ADDENDUM # 2

RE: **Dry Storage Building**
Piedmont Technical College
Greenwood, S.C.
CGD Project No. 25010
OSE Project No. H59-N309-TM

DATE: **January 13, 2026**

A FOUNDATION/ SLAB PLAN

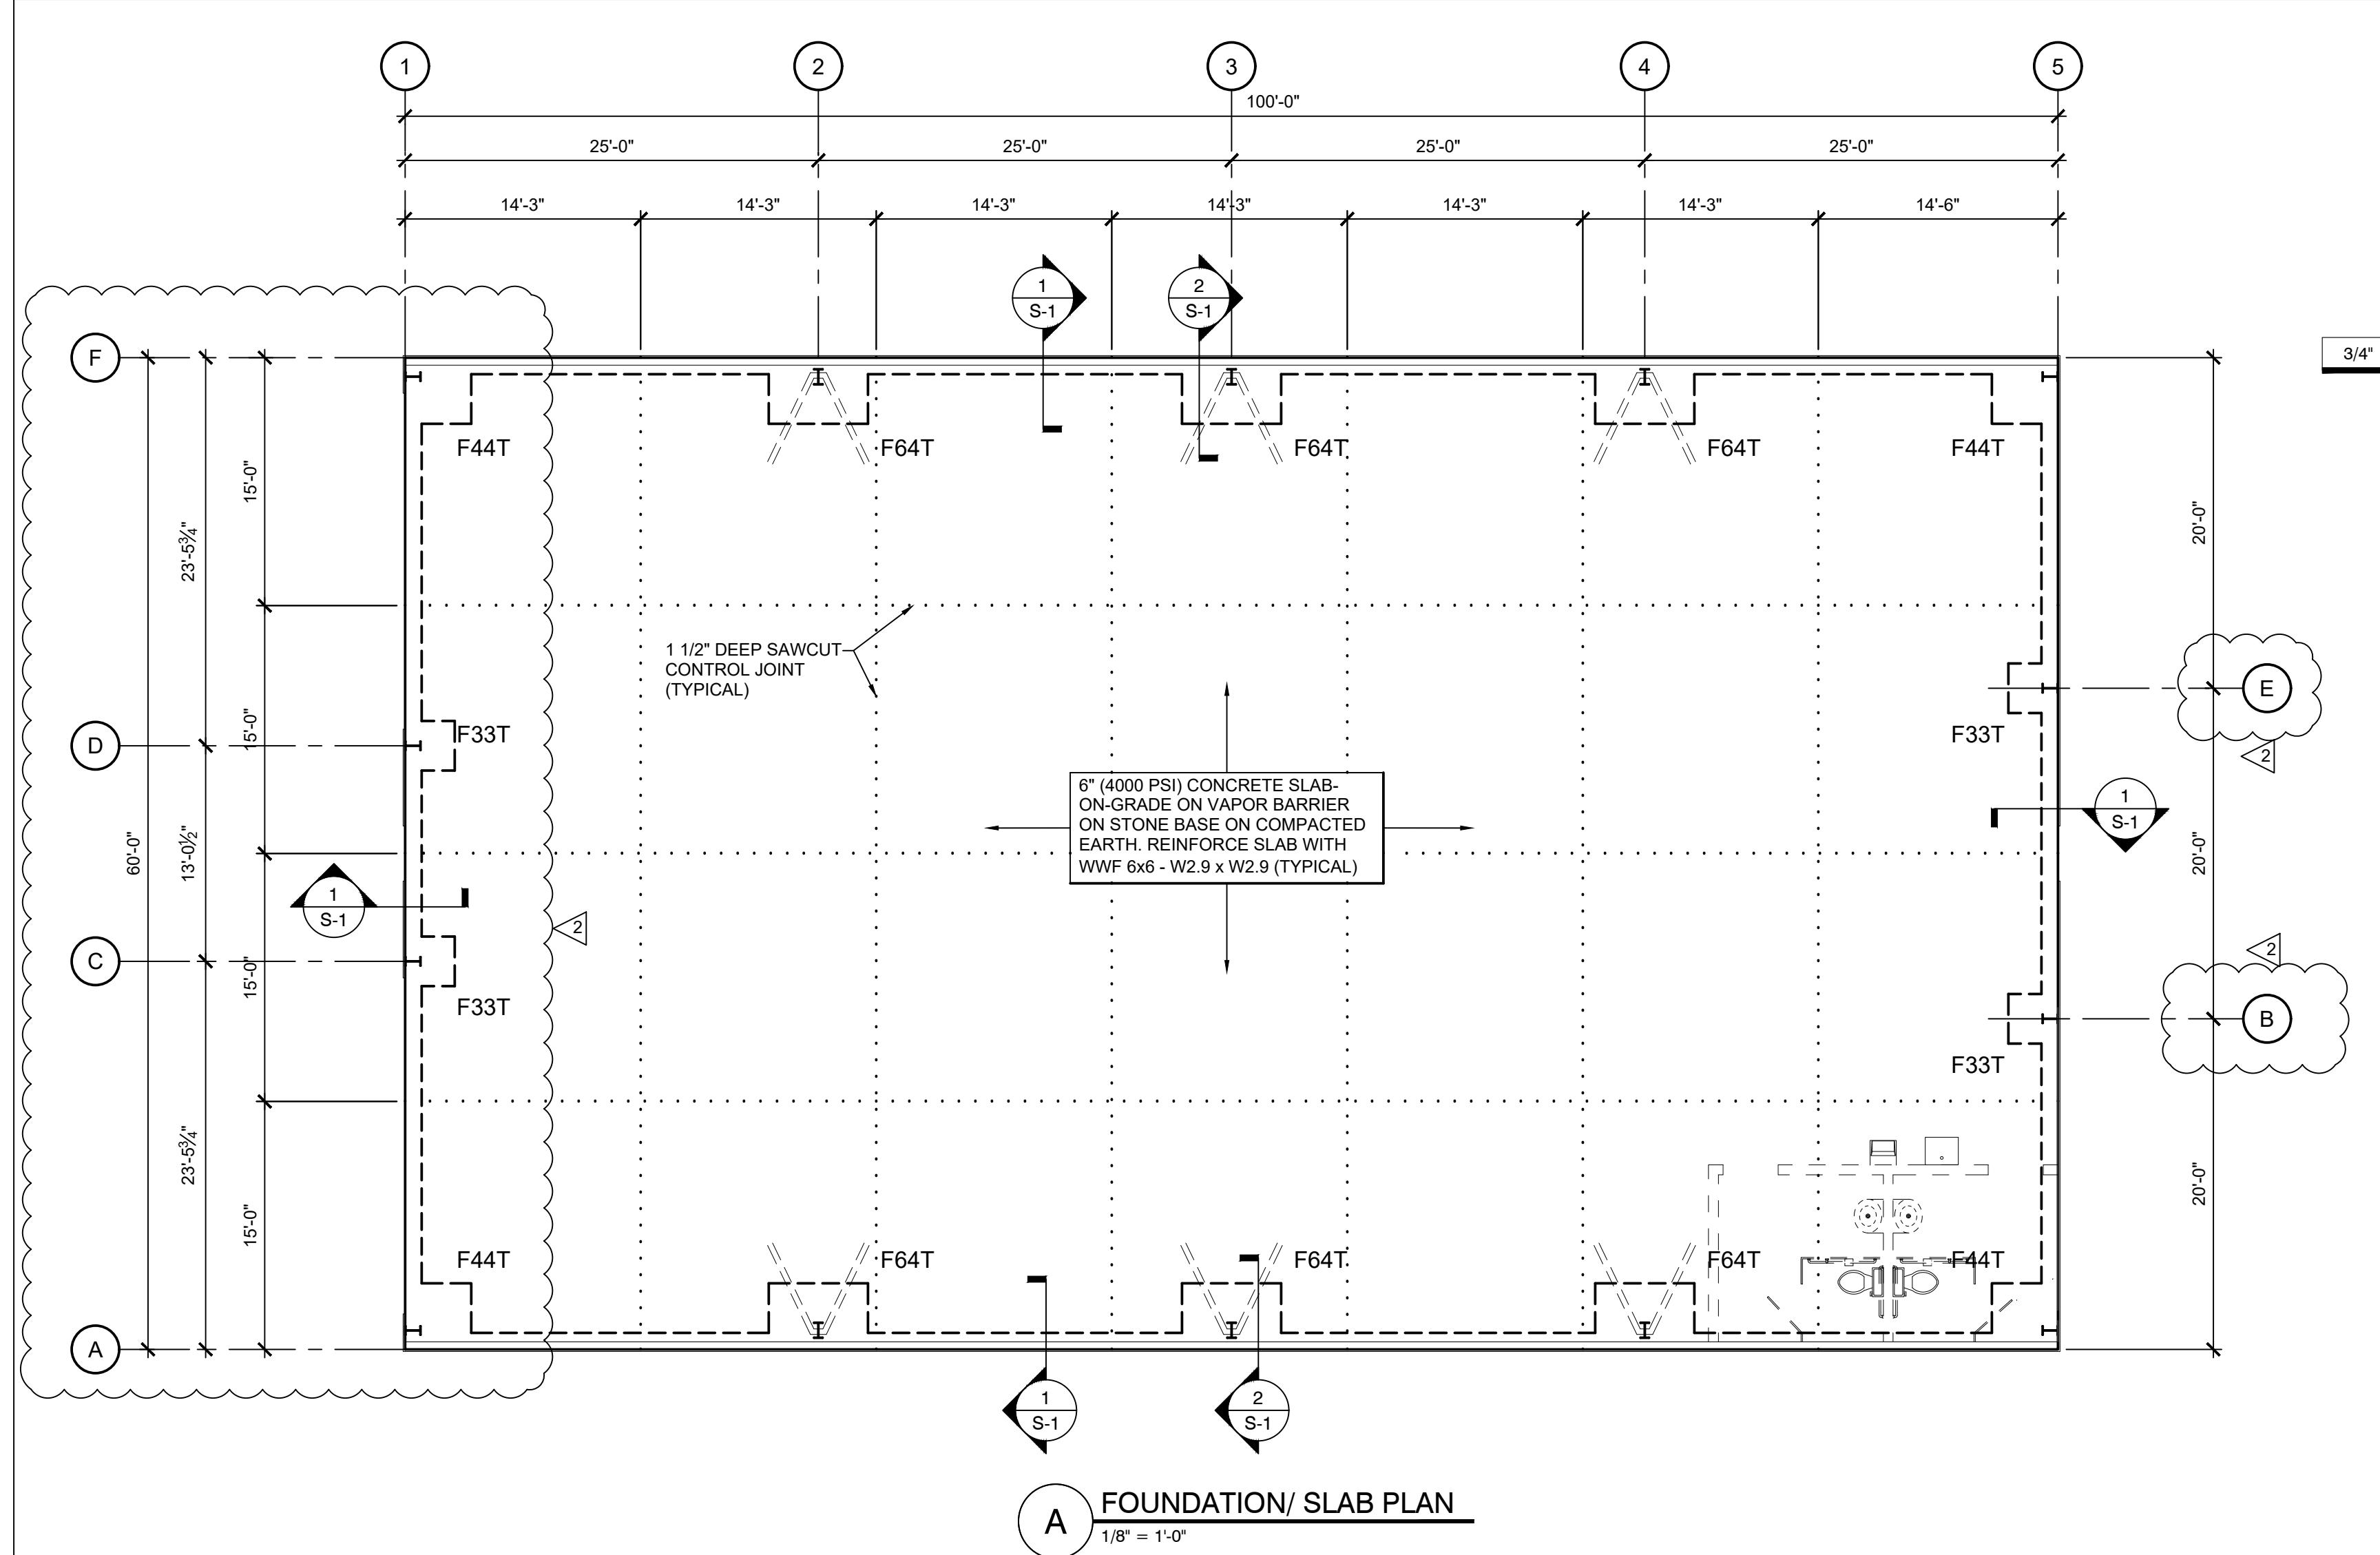
D1 Sheet S-2: Foundation/Slab Plan:

See revised Foundation/Slab Plan with corrected dimensions to align with architectural plans.
